CONVERSATION RECORD

SUBJECT

Letter dated 1-25-94 with commitments and attached survey

Attention: Mr. Loren J. Hueter <sup>02</sup>  
Reference: License Number 34-00850-22 Additional Information

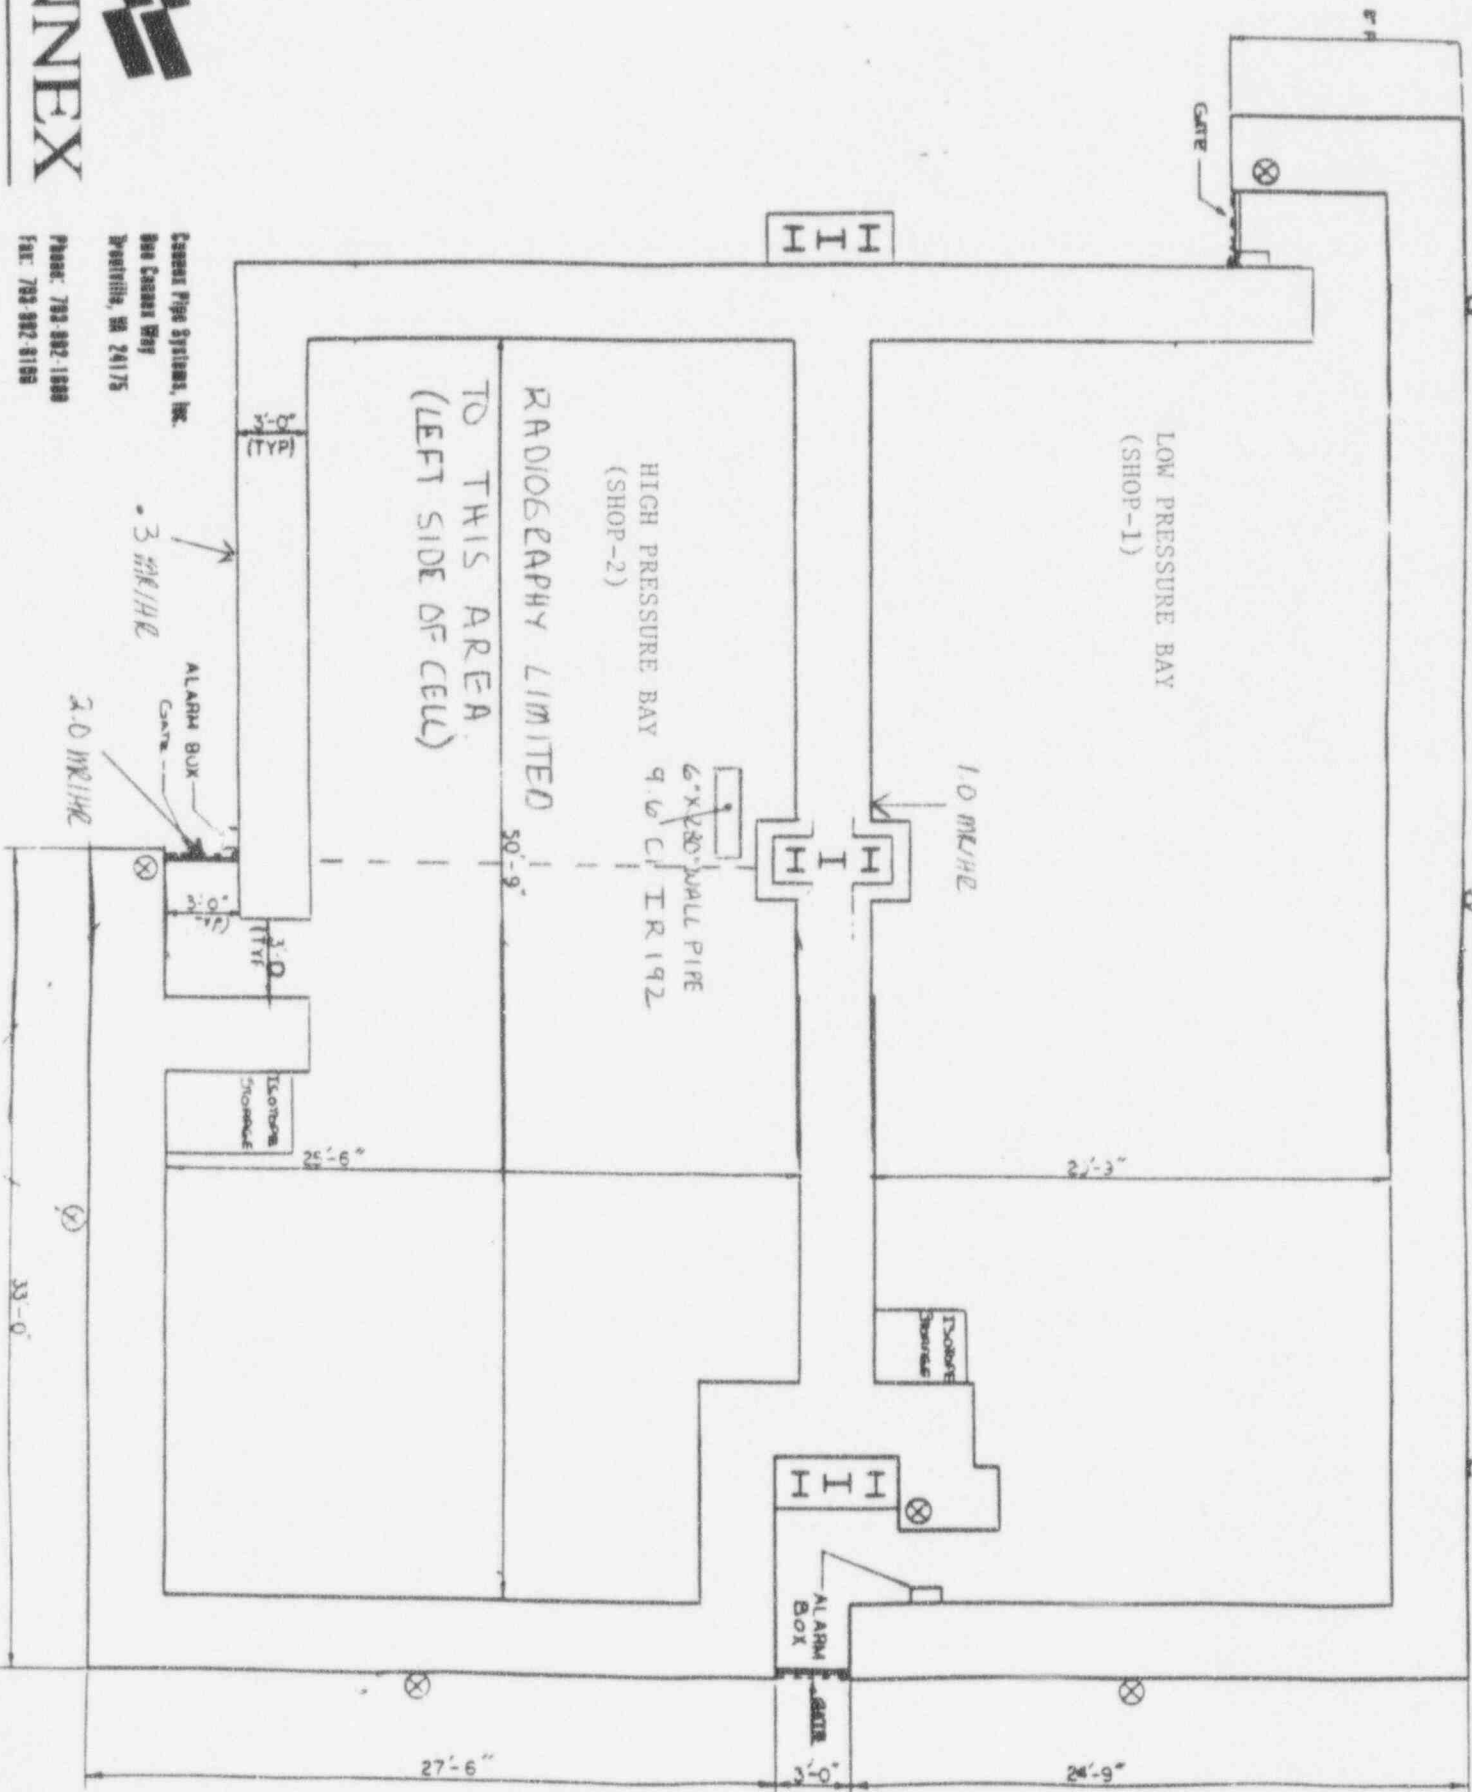
Confirmatory surveys had only been done on left half of high pressure Bay. Further, a detailed look at drawing (and confirmed by inspection by Mr. Nades) shows a near direct line of site with little shielding provided through the labyrinth at about a 45 degree angle.

However, they must modify (lengthen) walls of labyrinth entrance to high pressure bay, amend license (probably not to be done) and submit confirmatory survey before we will authorize use to the right of dotted line in high pressure bay as depicted in diagram attached to 1-25-94 letter.

I agreed to let them use the portion of the high pressure bay to the left of dotted line in diagram attached to 1-25-94 letter on basis of survey data & commitments submitted.

1. Radiography will be limited to the area to the left of the Cell until a suitable wall is placed (High Pressure Bay).
2. During normal operations, a 6" X .280" exposure on center using 30 Ci of IR192 would take seven (7) seconds, with set-up time, recentering the isotope, film placement, etc., we could radiograph four (4) welds in one hour substantially reducing the MR/HR at the door (See Attachment 1).
3. For the Low Pressure Bay, lines will be painted on the floor, as indicated, to assure radiography will not be performed in these areas.
